HISTORIC LANDMARKS COMMISSION

October 13, 2016

Subject: **REQUEST FOR CERTIFICATE OF APPROPRIATENESS HC-2016-19,** submitted by Kurt W. Werth of Church Development Services, LLC, agent, on behalf of First Baptist Church-Mahan, applicant and property owner, for (1) construction of a new 12,700 square foot building, (2) demolition of an existing detached annex building, and (3) additional site improvements including the expansion of the on-site parking lot, access drive improvements and landscaping enhancements on property located at 112 Mahan Street, Zoning Map 34G11, Block (A), Parcel(s) 101*102. Also included are Zoning Map 34G11, Block (A), Parcel(s) 98, 99, 100, 103, 104, 105, 106, 107, 108*109, 126 and 127*128. The affected area(s) are further identified as being located in the Suffolk Voting Borough, zoned RU, Residential Urban, CBD, Central Business District zoning districts and HC, Historic Conservation Overlay District.

STAFF REPORT

CONCEPTUAL SITE LAYOUT & LANDSCAPE PLAN OF

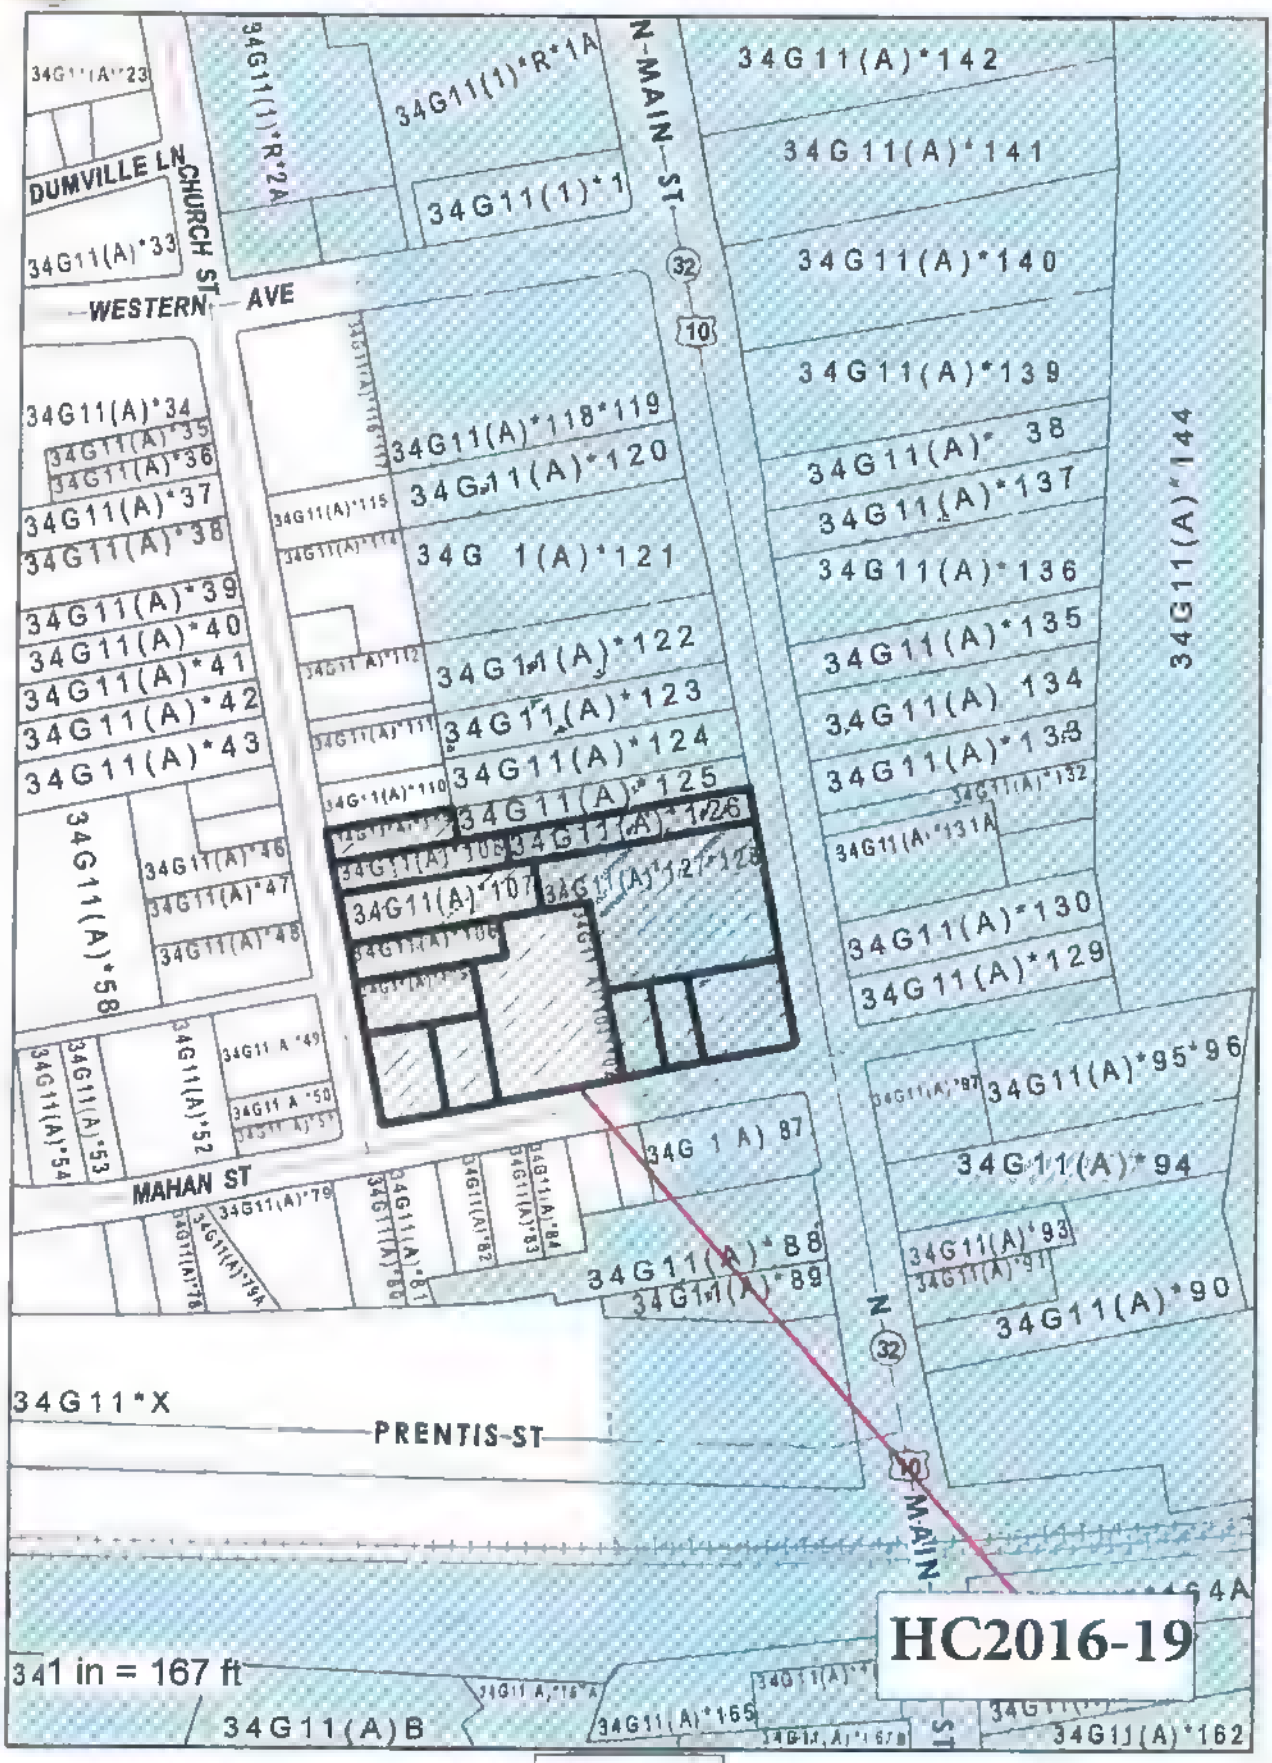
In addition to the proposed construction of the 12,700 square foot structure, several modifications to the site are planned. Specifically, outside of the Historic Conservation Overlay District, the Church plans to expand the parking lot area from the north to the south, towards Mahan Street west of the existing sanctuary. This will bring parking towards Mahan Street and the closest parking bay will be separated from Mahan Street by 15 feet of landscaped area. Additionally, on the Church Street side, this newly expanded area will be separated from the right-of-way by a 15 foot landscaped buffer. As mentioned above, this part of the proposed site improvements will be located outside of the Historic Conversation Overlay District.

Presently, the site has two (2) points of ingress/egress. One (1) point is on N. Main Street and the other is opposite of this point, on Church Street. The access point off of N. Main Street, which is

within the district, will be enhanced. Presently, this point is approximately 20 feet in width. Plans call for the widening of this access point by increasing its width to 25' and flanking it with green area on both its north and south.

Plans also call for the creation of a dumpster pad at the north of the Church Street point of access. Provided materials show that the dumpster pad will be screened utilizing enhanced vegetation. Plans do not indicate an enclosure for the pad site. This particular area is located outside of the district.

4. All site improvements are subject to review through the City of Suffolk's site plan approval process.
